Informal Document No. 10
(50th GRE, 7-11 April 2003,
agenda item 3.3.)

PROPOSAL FOR DRAFT AMENDMENTS TO DRAFT REGULATION ON
ADAPTATIVE FRONT-LIGHTING SYSTEM (AFS)

Transmitted by the Expert from Poland

Note: The text reproduced below was prepared by the expert from Poland, in order to change the co-ordinate system for defining photometric requirements from 25 m screen to road level surface (RS) and surface at the eye-level of the glare exposed drivers (GS) "First step". It refers to document TRANS/WP.29/GRE/2002/18.

"Figure 1: Position of passing beam photometric requirements on the road surface (RS) for class C, V, W, E.

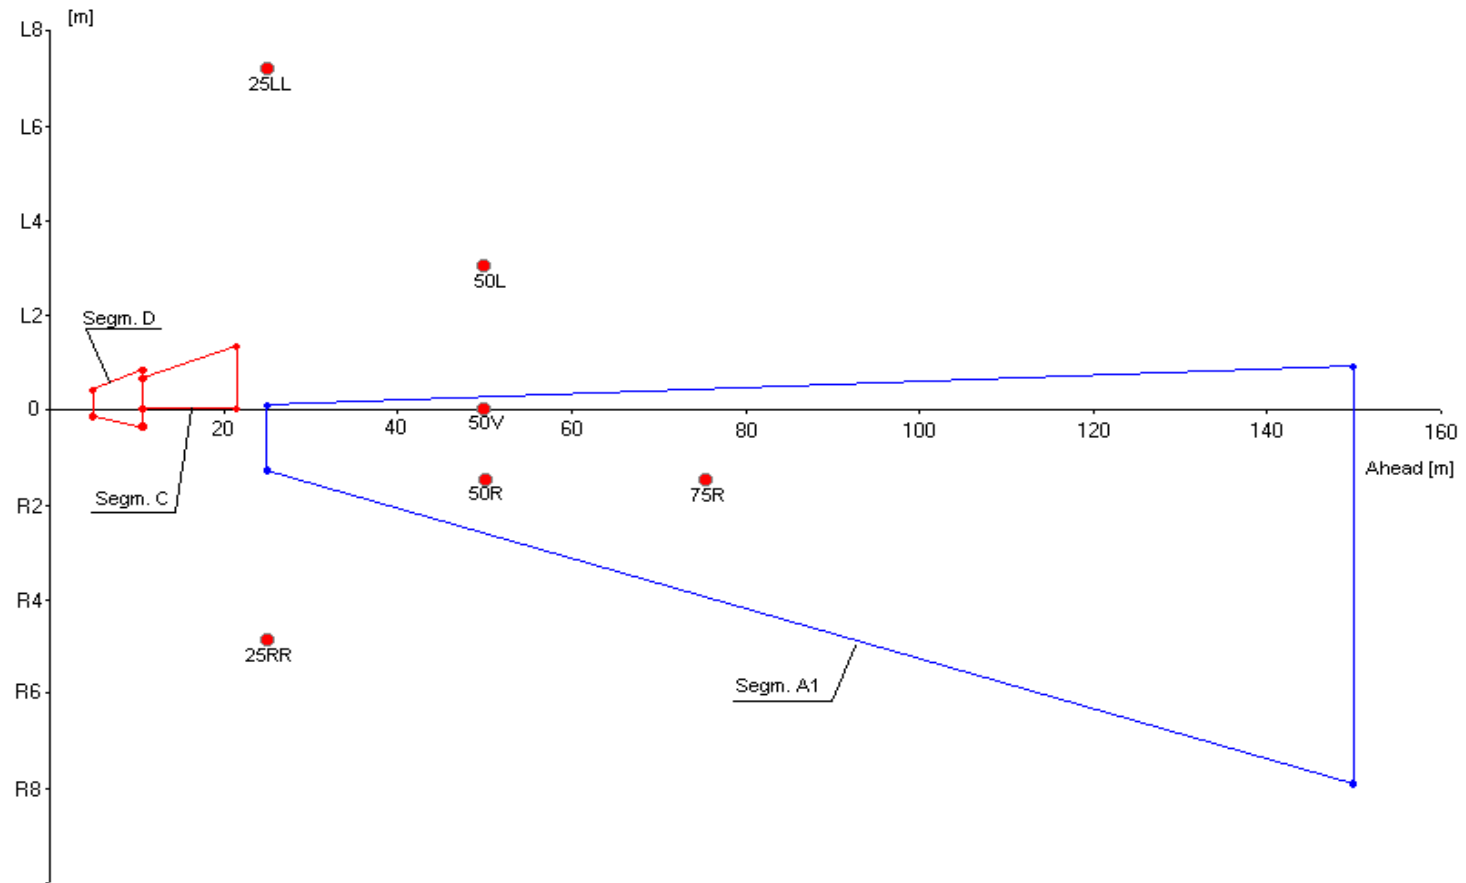
Insert new figures 1, 2 and 3 and tables 1, 1a to 1d, to read:

Fig. 3. Present view of vertical intersection of old and proposed co-ordinates system.

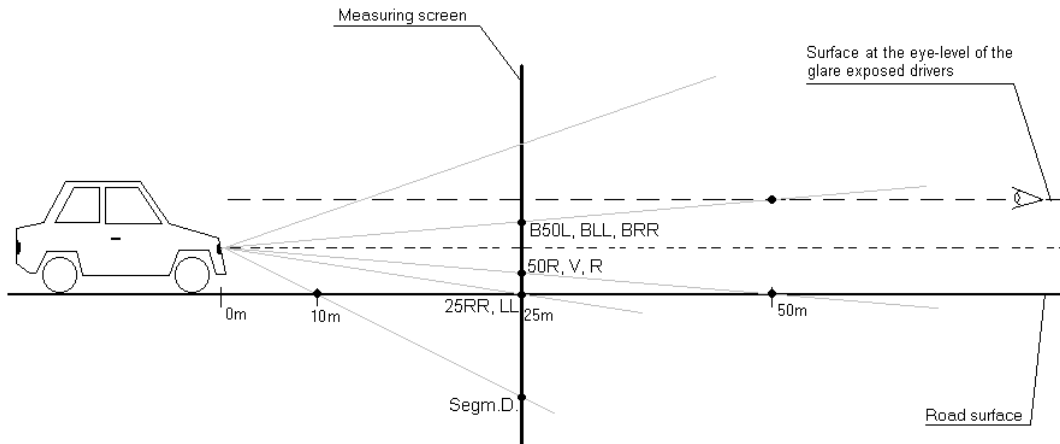
It is proposed to redefine the co-ordinates system for which the requirements are defined. The new co-ordinates system consist of two surfaces: road level surface (RS) and glare exposed drivers eyes level surface(GS), situated parallel to the road.

It is also important that the laboratory measuring equipment and methods are unchanged. The goniophotometer is still the basic tool for measurements. The only need is to **recalculate** the results from an angular coordinate system to RS and GS. There are **relatively simple recalculations** which can easily be done using a computer program like MS Excel. Fig. 3. shows vertical intersection 25 m screen co-ordinates system and proposed co-ordinates system.

Fig. 4. Bird's - eye view of proposed co-ordinate systems: road surface and oncoming drivers' eyes' surface.

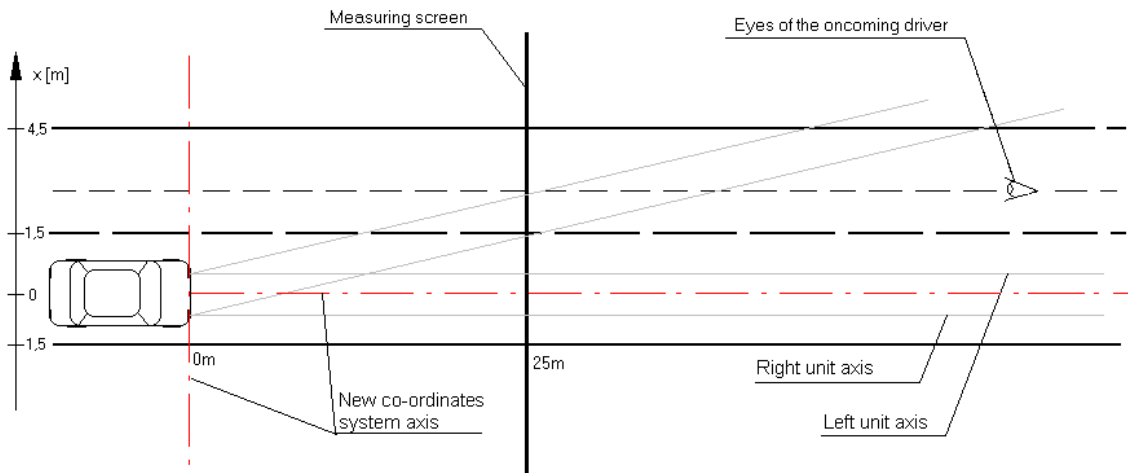
Fig. 4. shows bird's - eye view of RS and GS. It is easy to see that each element (Table 1 to 4 of TRANS/WP.29/GRE/2002/18) of measuring screen has its own representation on described surfaces (RS- road surface; GS-glare surface).

Fig. 5. Measuring screen and its representations on RS.

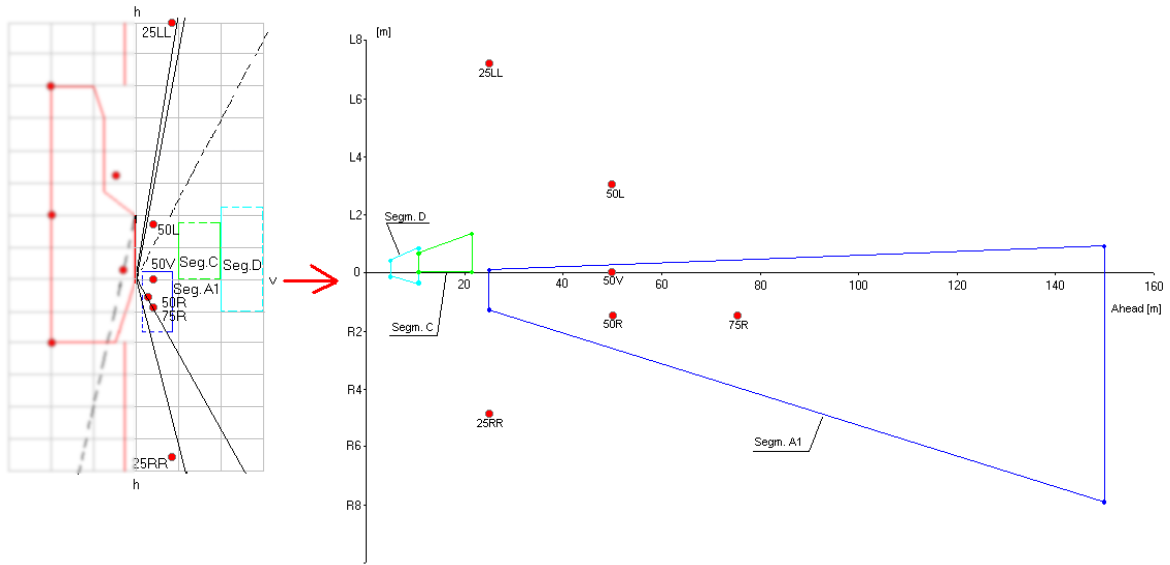
Fig. 5. and Fig. 6. shows measuring screen and representation of its contents on RS and GS.

Fig. 6. Measuring screen and its representations on GS.

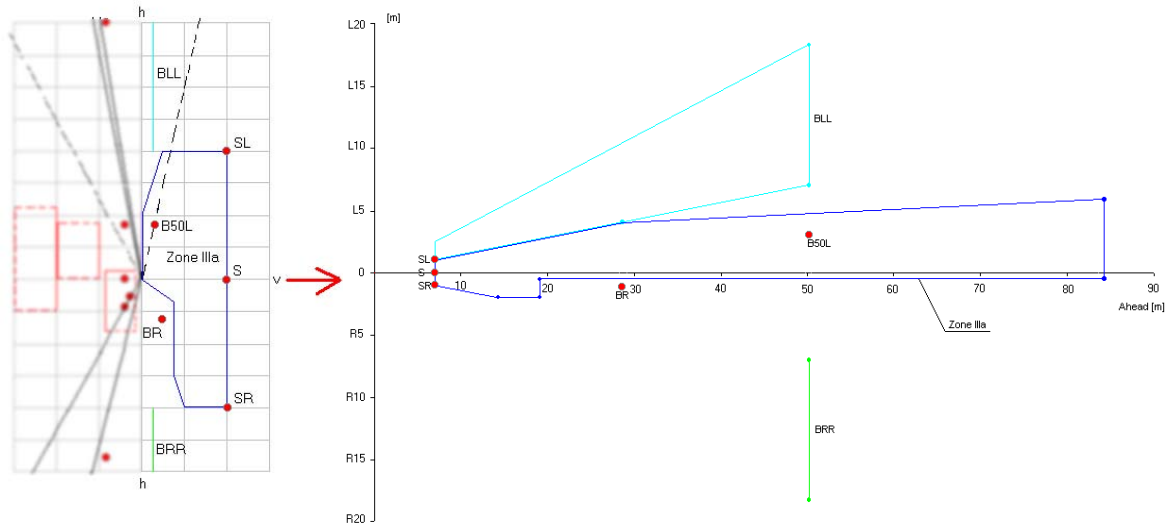
A visible double edge is the result of calculations for two units in distance of 100 cm. Subscripts L , R and $L+R$ means areas for left, right and both headlamps. E.g. $B50L_L$; $B50L_R$.
